Subject: Transmittal of Revision 5 to Service Bulletin Number  
V2500-ENG-72-0011

**International Aero Engines**  
**SERVICE BULLETIN**

ENGINE - HP TURBINE ROTOR AND STATOR ASSEMBLY - REWORK THE STAGE 2  
TURBINE HUB ASSEMBLY TO INCORPORATE A TURBINE HUB HEATSHIELD

**V2500 – ENG – 72 – 0011**  
Page 1 of 18

Figure 1

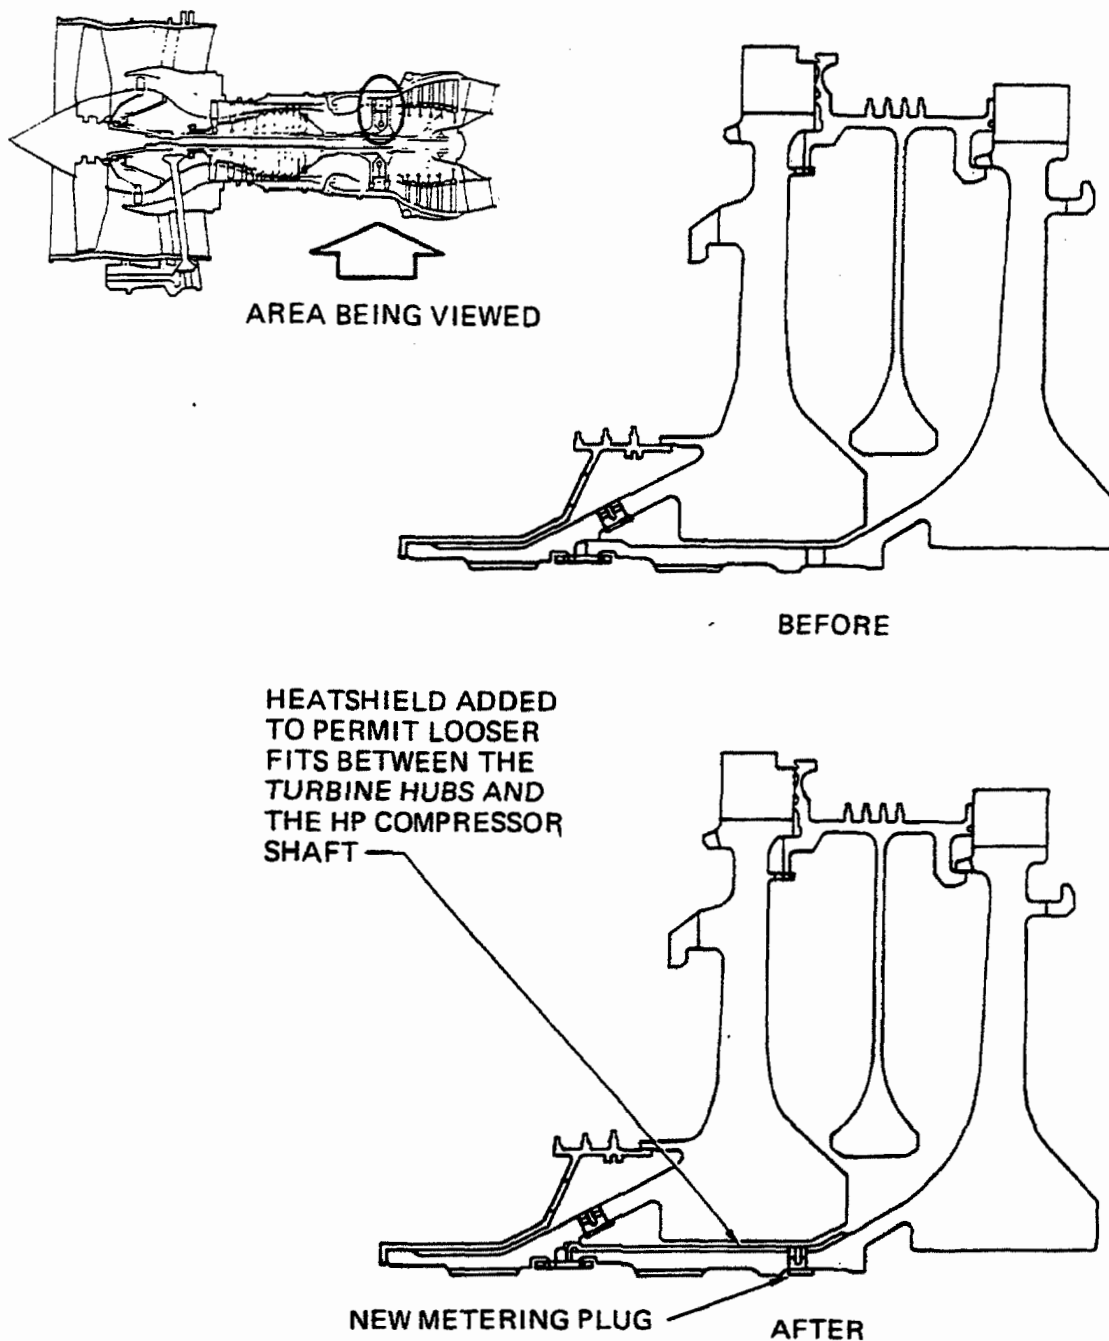
- (1) Removal and Installation of the Stage 1 and 2 HPT Hubs and the HP Compressor Shaft is improved. This change prevents galling on the HP Turbine Hubs as follows:

- (a) A heatshield was installed to loosen fits between the Turbine Hubs and the HP Compressor Shaft. Refer to Figure 1.
- (b) A change was made to the Hub dimensions to permit installation of the Heat Shield.
- (c) New metering plugs are installed to maintain Disk and Heatshield alignment.

Modification of the stage 1 turbine hub  
Figure 2

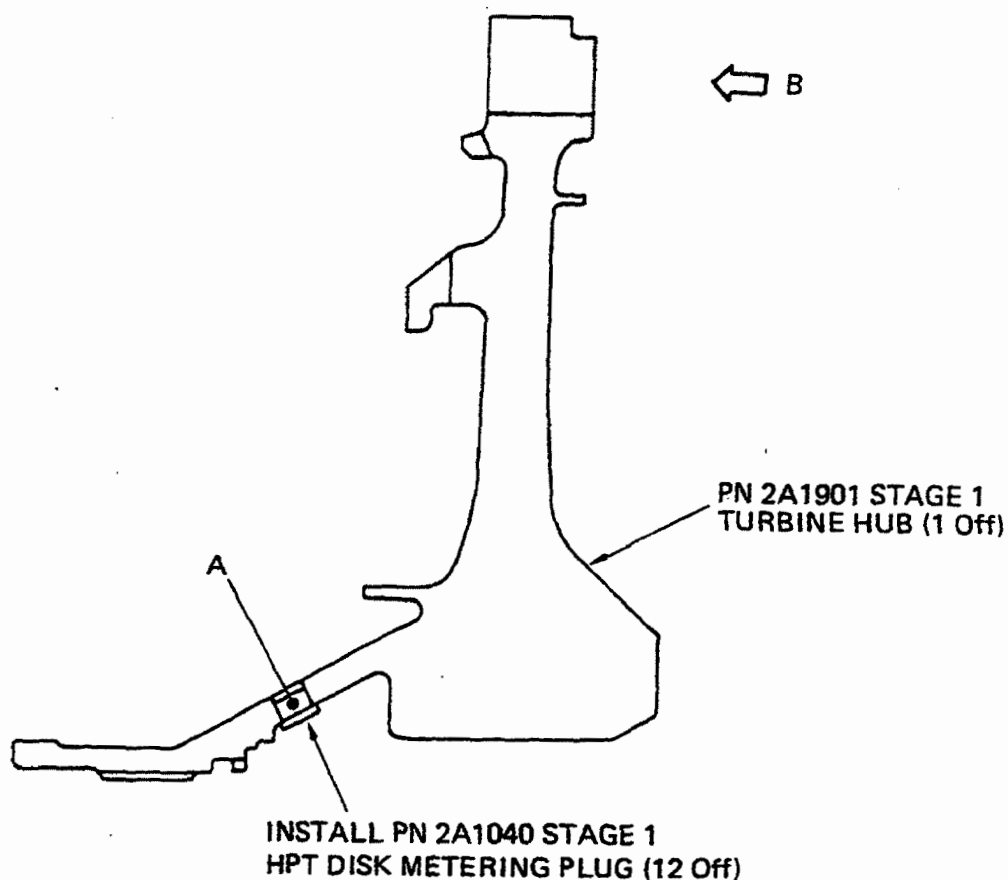
- (a) Send the Stage 1 Turbine Hub to the approved vendor to be machined.
- (b) Shot peen the Stage 1 Turbine Hub to an intensity of 6A. Use SAE 170 Maximum Cast Steel Shot with a hardness of 45 - 55 HRC or equivalent.
- (i) Minimum intensity is waived in Area K.
- (ii) There must be full coverage.
- (c) Mark the new part number adjacent to the old part number. Use the vibration peen method.

Refer to Figure 2 requirements. Refer to the approved procedure in Reference (2) Control No./TASK No. 70-38-13-380-501.

Refer to Figure 2, requirements. Refer to the approved procedure in Reference (2), Control No./TASK No.70-09-00-400-501.

<u>Old Part Number</u>	<u>New Part Number</u>
2A1101	2A1901

Modification of the stage 1 turbine hub (Installation of disk metering plugs)  
Figure 3

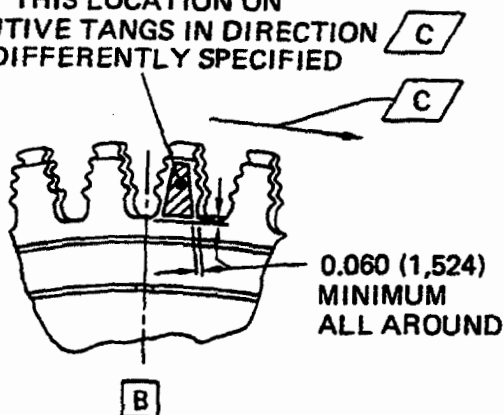
- (d) Install 2A1040 Metering Plugs (12 off) in the 2A1901 Stage 1 Turbine Hub.

Refer to Figure 3, requirements.

- (e) Mark the new assembly part number adjacent to the old part number. Use the vibration peen method.

<u>Old Part Number</u>	<u>New Part Number</u>
2A1121	2A2021

Modification of the stage 2 turbine hub  
Figure 4

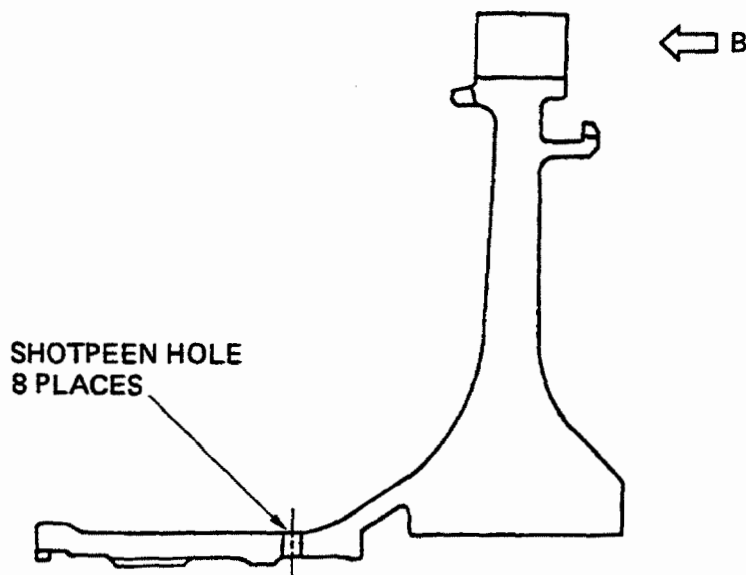
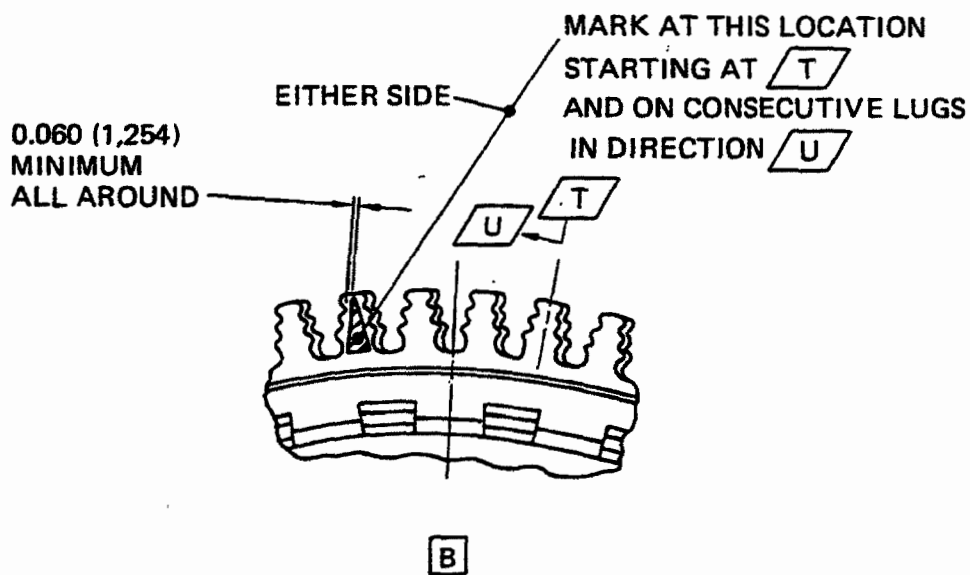
- (a) Send the Stage 2 Turbine Hub to the approved vendor to be machined.
- (b) Shot peen the Stage 2 Turbine Hub to an intensity of 6A. Use SAE 170 Maximum Cast Steel Shot with a hardness of 45 - 55 HRC or equivalent.
  - (i) No masking is necessary.
- (c) Mark the new part number adjacent to the old part number. Use the vibration peen method.

Refer to Figure 4 requirements. Refer to the approved procedure in Reference (2) Control No./ TASK No.70-38-13-380-501.

Refer to Figure 4, requirements. Refer to the approved procedure in Reference (2), Control No./ TASK No.70-09-00-400-501.

<u>Old Part Number</u>	<u>New Part Number</u>
2A0902	2A1302

Figure 5

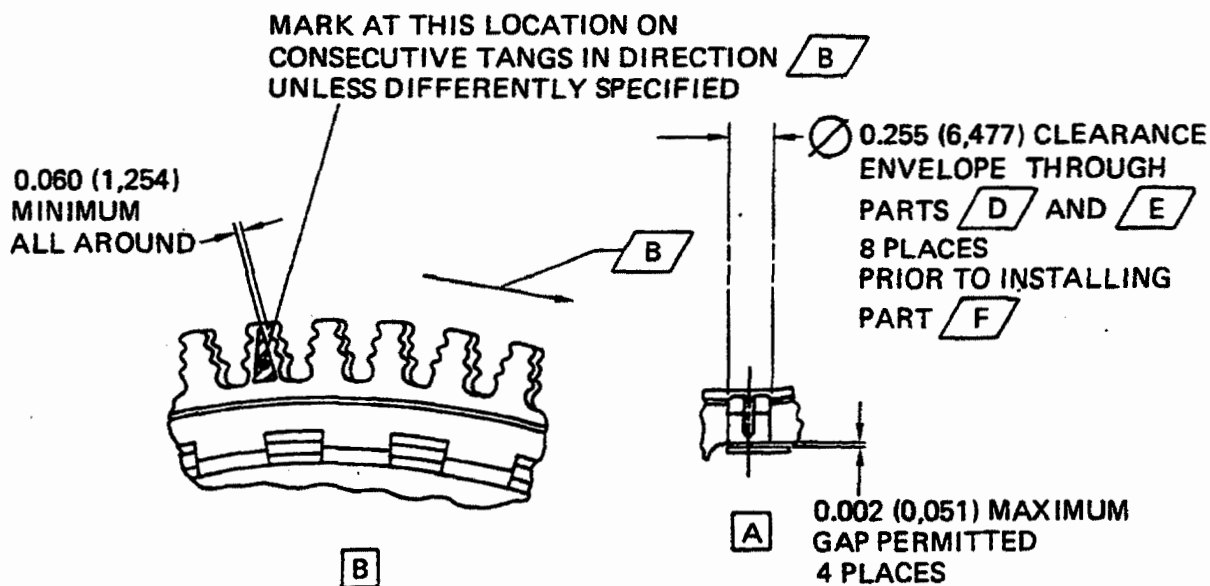
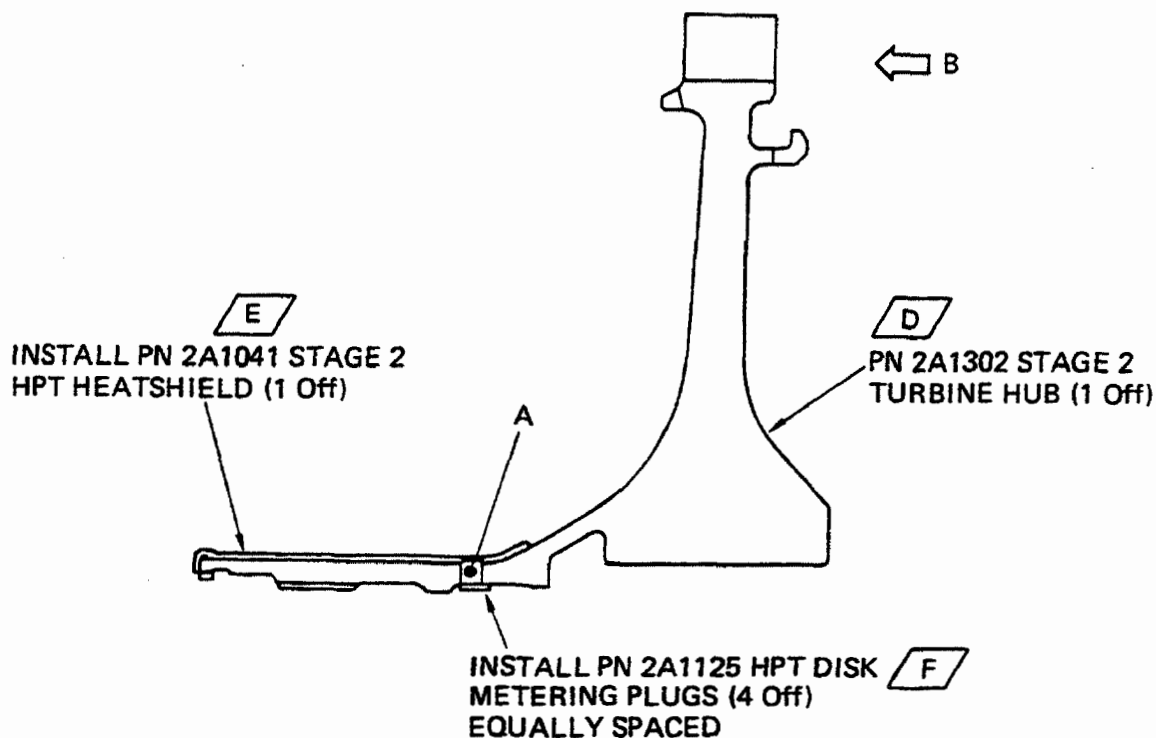
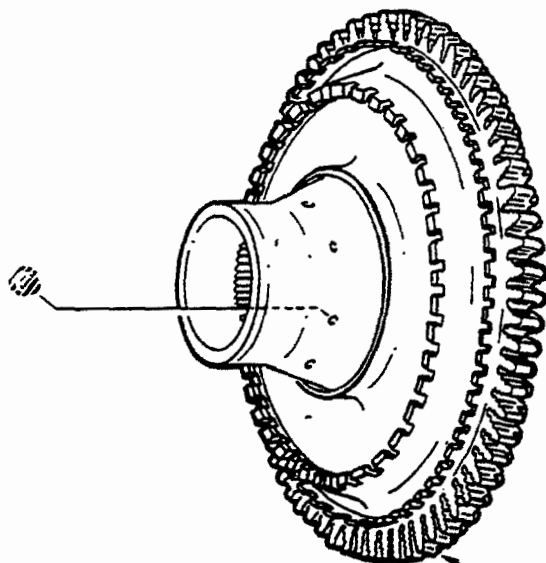
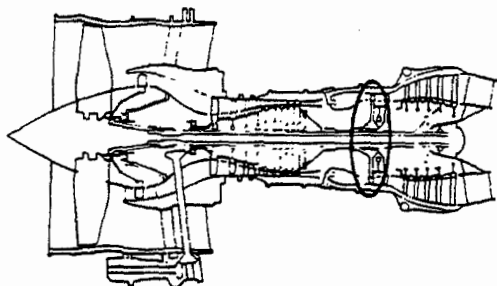
- (d) Install 2A1041 Stage 2 HPT Heat shield (1 off) on the 2A1302 Stage 2 Turbine Hub (1 off).
- (e) Install 2A1125 HPT Metering Plugs (4 off) in the four holes from the inside (flanged end to contact the inner diameter of the hub).
- (f) Mark the new assembly part by the approved procedure. Use the vibration peen method.

Refer to Figure 5, requirements.

Refer to Figure 5, requirements.

Refer to Figure 5, requirements. Refer to the approved procedure in Reference (2), Control No./ TASK No.70-09-00-400-501.

<u>New Part Number</u>
2A1702

Location of stage 1 turbine hub assembly  
Figure 6

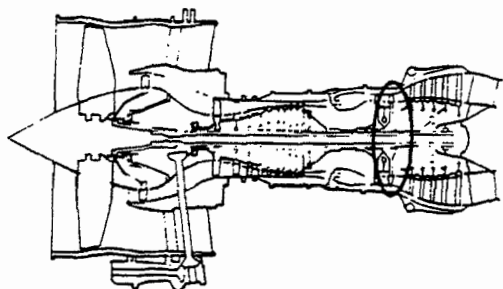
- (a) Use 2A2021 Stage 1 Turbine Hub Assembly (1 off). Refer to Figure 6.
  - (b) Identify 2A1621 Stage 1 Turbine Rotor Assembly to 2A2321. Use the vibration peen method in Reference (1), Chapter/Section 70-09-00, Marking of Parts. See Figure 1.

REMOVE PN 2A1121 STAGE 1  
TURBINE HUB ASSEMBLY AND  
INSTALL PN 2A2021 STAGE 1  
TURBINE HUB ASSEMBLY (1 OFF)

Location of stage 2 turbine hub assembly  
Figure 7

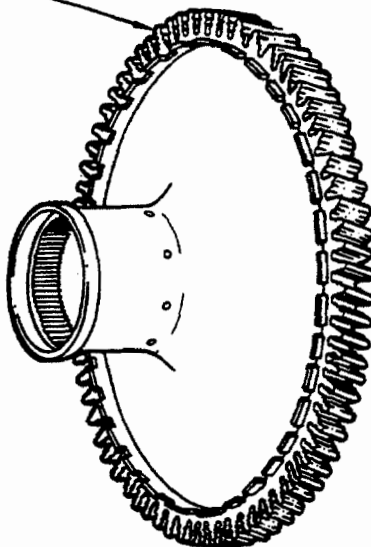
- (a) Use 2A1702 Stage 2 Turbine Hub Assembly (1 off). Refer to Figure 7.
  - (b) Identify 2A1022 Stage 2 Turbine Rotor Assembly to 2A1722. Use the vibration peen method given in Reference (1), Chapter/Section 70-09-00, Marking of Parts. See Figure 2.

REMOVE PN 2A0902 STAGE 2  
TURBINE HUB AND INSTALL  
PN 2A1702 STAGE 2 TURBINE  
HUB ASSEMBLY (1 OFF)
